1015 N MAIN STREET – Siding Replacement, Window Replacement, Rear Addition (25-82-COA)

CITY OF HENDERSONVILLE - COMMUNITY DEVELOPMENT - HISTORIC PRESERVATION
COA STAFF REPORT

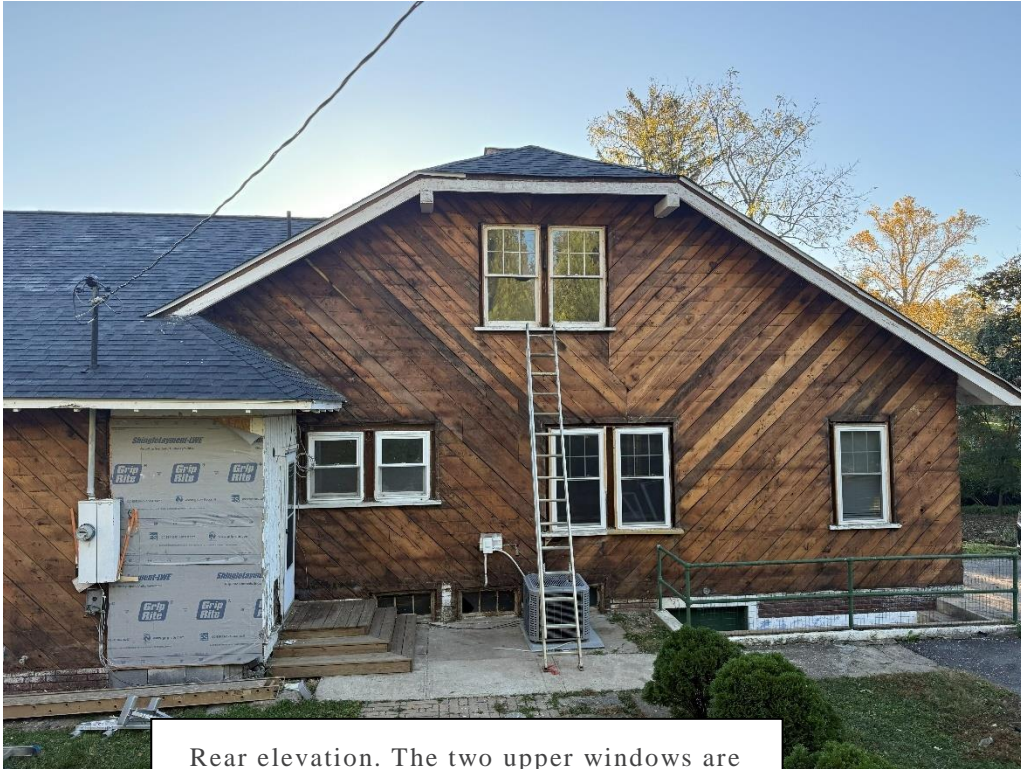
Rear elevation. The two upper windows are proposed for replacement.
